Baldwin County Planning Commission Staff Report

**Case No. SPP25-44
Point Clear Golf Club Ph1 B
February 5, 2026**

Request: Preliminary plat approval for a residential subdivision

Plat Ph 1B

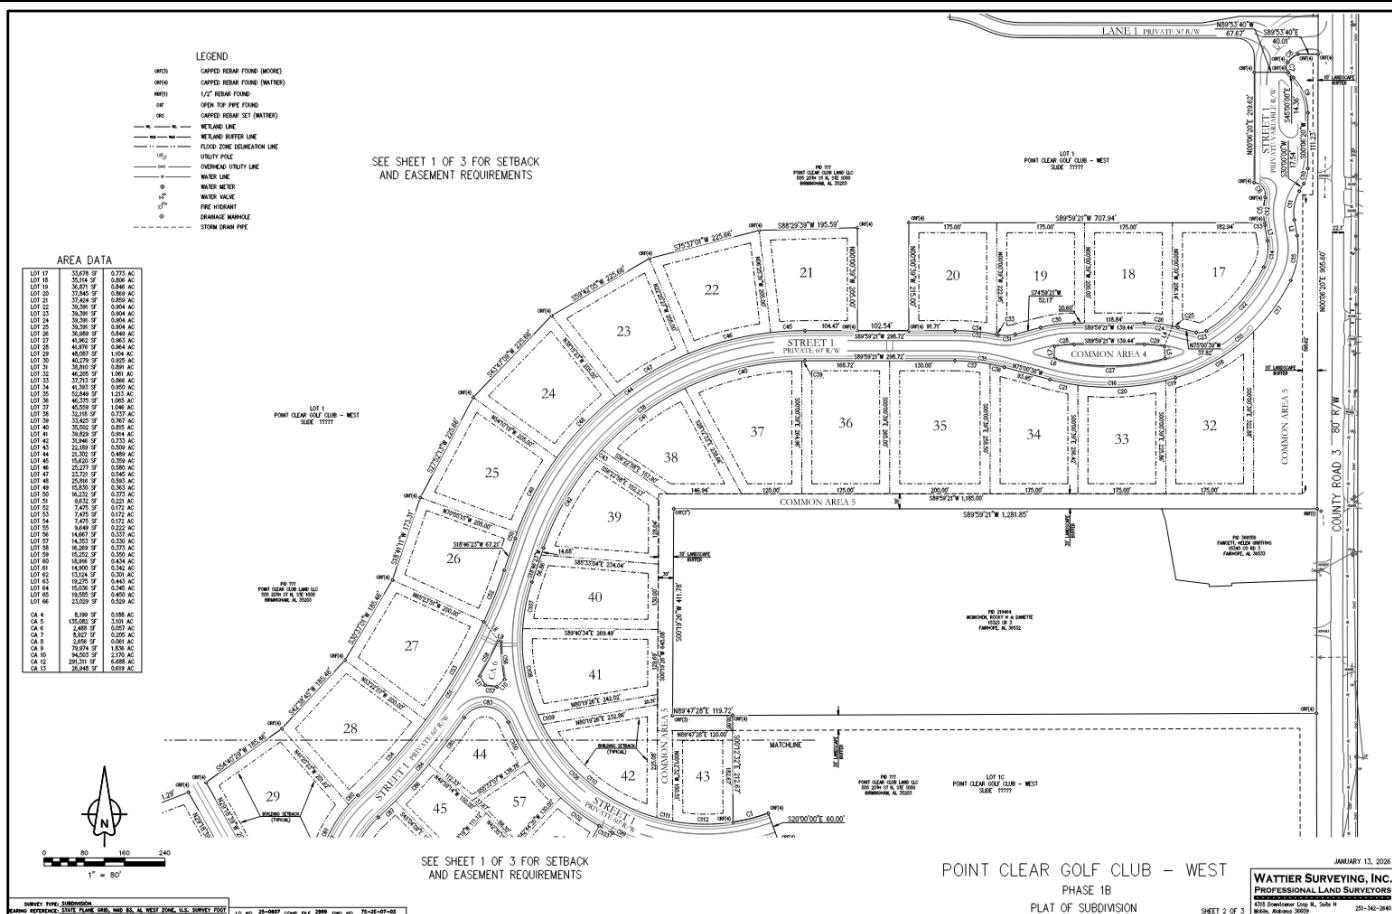
1. Provide a E-911 Address Verification letter for the proposed streets.
2. Provide a revised Operation & Maintenance Plan (O&M)
3. Revise the landscaping Plan to reflect the required stormwater ponds as per section 6.2.2(b) 2 of the Subdivision Regulations.

4. The applicant shall coordinate with the Baldwin County Planning and Zoning and Highway Department as the traffic study is being reviewed by a third party consultant to determine the requirement of traffic improvements.

5. The applicant shall record with the Judge of Probate's office the approved exemption (PF25-327) for the common movement of property lines to reflect the boundary of each proposed phase.

6. The four phases shown on Preliminary Plat (1A, 1B, 1C and golf course/clubhouse) will be required to obtain CPR (Construction Plan Review) prior to commencing construction.

7. No work may commence in wetlands until the necessary US Army Corps of Engineers wetland permit has been obtained.
